June 16, 2025

Re: Response to Requests for Additional Information, Disa Technologies, Inc., License Application for a Performance-Based, Multi-Site Radioactive Materials License to Operate a High-Pressure Slurry Ablation Remediation System, Revision 3, Docket 40-38417

Figure 7-1: Model Components and Grid System Dose Model

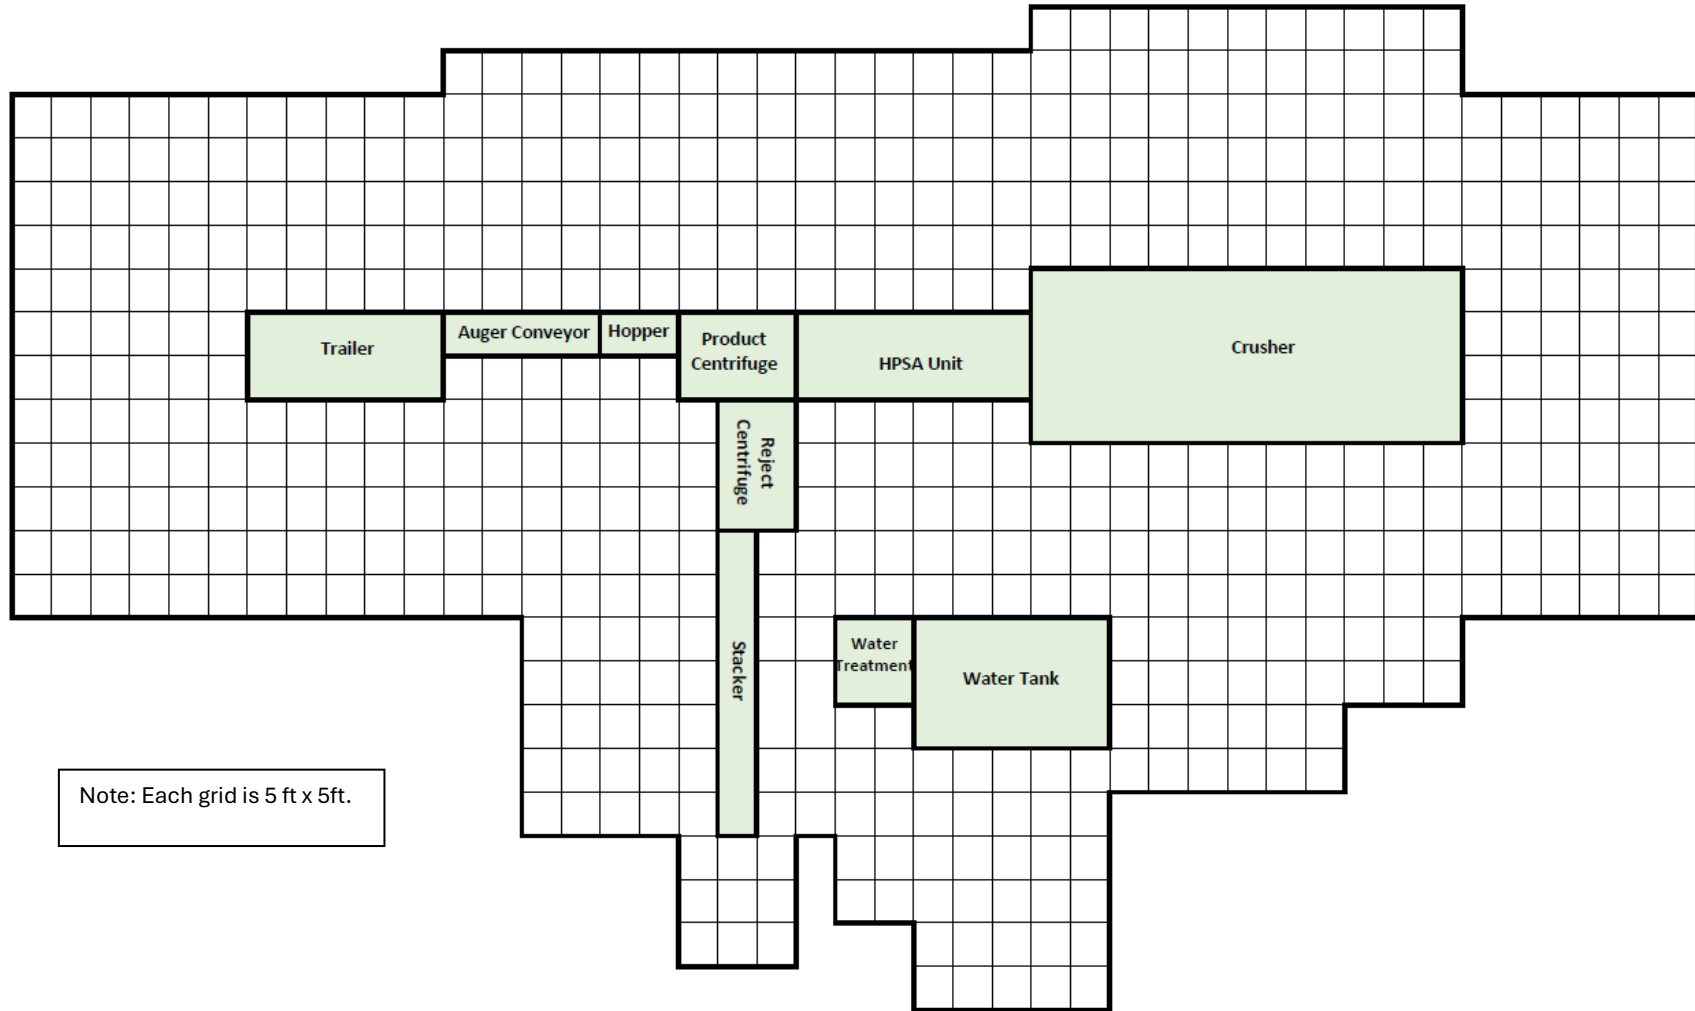
Additional information is needed regarding dose assessment for sites with more than one HPSA unit operating concurrently. Alternatively, please provide justification for why the occupational and public doses would not be expected to change with additional HPSA systems operating concurrently at a temporary jobsite.

Additional modeling has been performed to investigate how dose rates to the public vary when multiple HPSA units and additional fines storage trailers are present during operations. Section 7.0 has been updated to discuss the modeling results (Attachment 3). Conservative and simplifying assumptions (i.e., protective) were made using the Tier 5 parameters (i.e., based on parameters in Table 4-1 of the Application). Associated with this (and related to RAI 6. HP-3 below), the public dose occupancy time assumptions have been revised to be consistent with guidance found in NUREG-1556 Volume 12 Appendix J (Table J-1). This guidance suggests an occupancy factor of 1/40 (0.025) for situations which meet the following description "Outdoor areas with only transient pedestrian or vehicular traffic, unattended parking lots, vehicular drop off areas (unattended), stairways, and unattended elevators". Calculated public annual dose rates have been adjusted (for previous modeling and the recent modeling) to account for this occupancy.

- **Modeling Extents** - As seen in Figure 7-2, occupational dose rates were modeled up to 20-30 feet from the surfaces of equipment. This is a limiting factor in the model results and is related to the software modeling capabilities. To model the potential public doses, an average distance of 50 feet from equipment was modeled. This distance varies slightly depending on the layout and size of the equipment. This distance represents a potential restricted area, beyond which no members of the public would be allowed access.

Figure 7-3: Source Term and Receptor Locations for MILDOS Internal Exposure During Operations Model

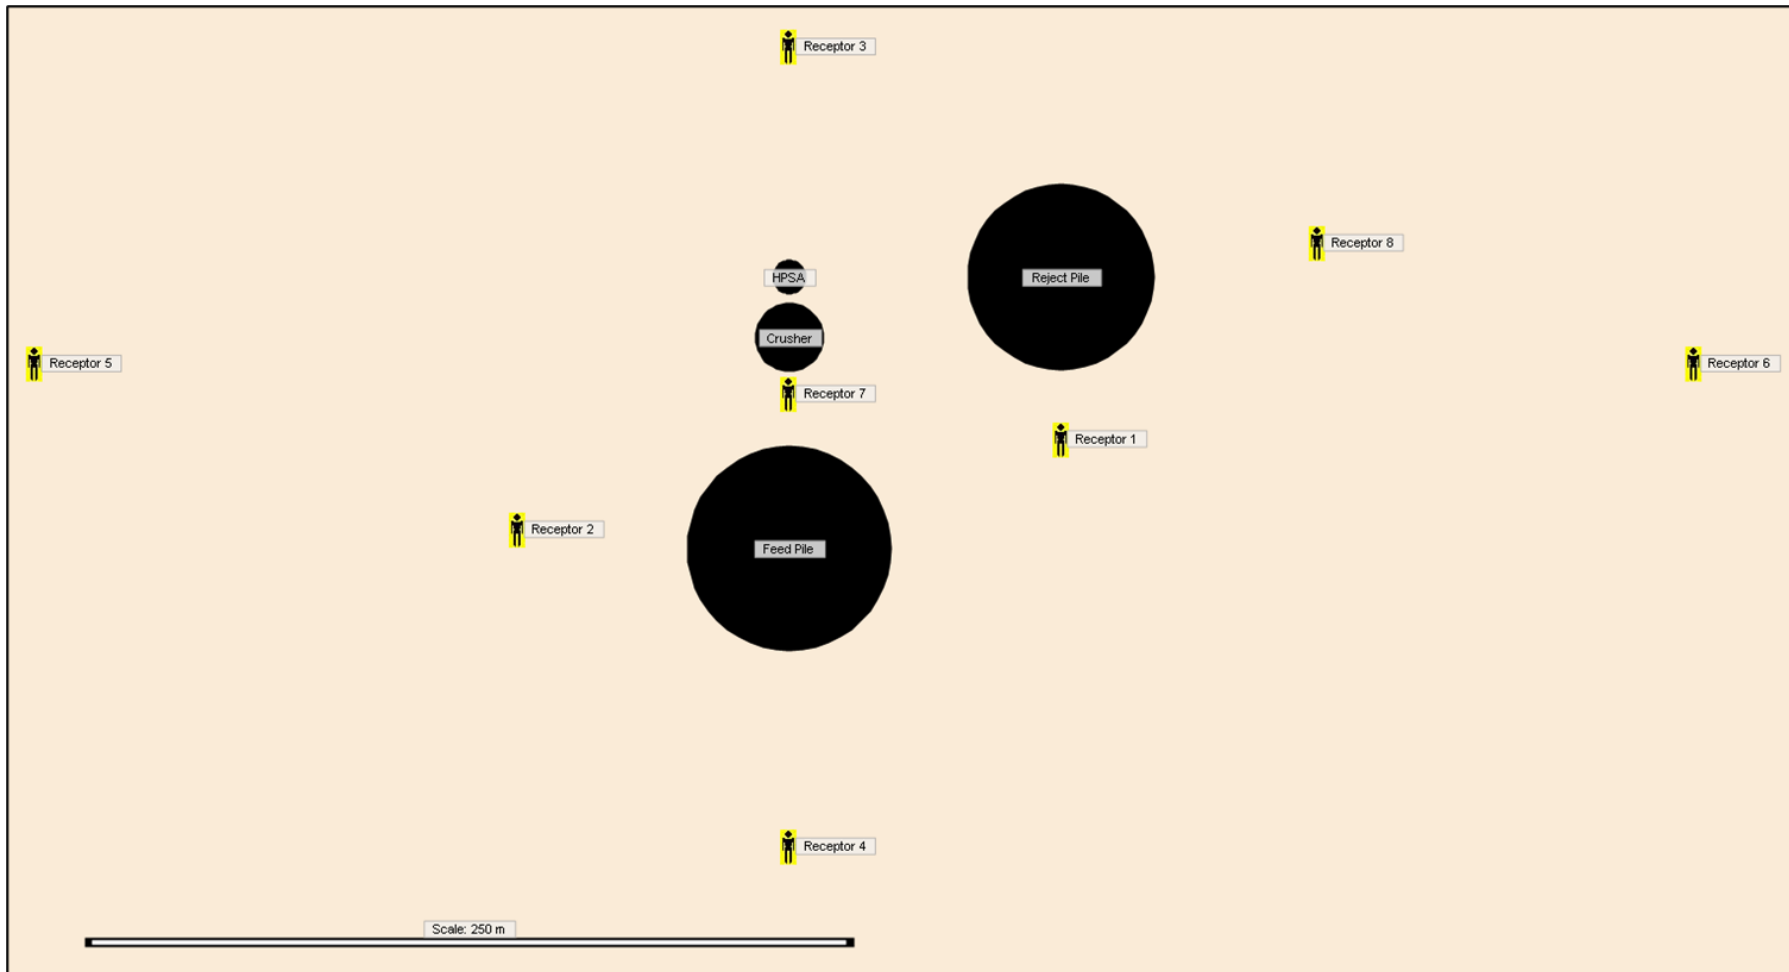
Additional information is needed to support the calculated public dose during operations, to release a site for unrestricted use, and post-demobilization, under the recreational use scenario. In order for NRC staff to be able to validate Disa's calculated public dose for these scenarios, please provide information regarding the assumptions and description of the recreational use scenario, justification of calculating the external public dose at 1 foot from the pile of coarse material rather than at the edge of the pile or the middle of the pile post-demobilization, and justification for calculating the internal public dose at 254 feet from the edge of the pile rather than next to the pile. For the modelled doses, the input and output sheets should be provided, and the formulas (if calculated) or input values (if modelled) should be provided to allow the NRC staff to verify the dose. If default values are used in the modelling, please indicate which defaults and if site information is used, please provide the origin of that information.

Some additional tables with source and receptor information for the internal dose models (during operations) have been added. All doses (internal or external) are modeled, and calculations are limited to simple sums (e.g., TEDE = DDE + CDE). Microshield and MILDOS input/output files can be provided if necessary. Source and receptor locations and source information (such as source concentrations) are now provided in tables. Any other parameter, including wind rose data, was assumed to be the modeling program default (see MILDOS Technical Manual Ver. 4.1). Wind rose data will vary highly from site to site, so it is assumed the default wind rose is as applicable as any other wind rose for this modeling effort.

With the updates described in HP-2 and HP-3 RAIs, the previous maximum external dose rate (e.g., 74 mrem/yr) is now reported as 11 mrem/yr. The internal dose rate has remained the same at 6.1 mrem/yr. This results in a maximum TEDE during operations of < 20 mrem/yr. The conservatism in these results is explained in previous RAIs and in the application document. Because of the monitoring to be performed during operations (exposure rate, air monitoring, etc.) and the ability to adjust boundaries accordingly, Disa feels strongly that public doses to the public will remain well below public dose limits.
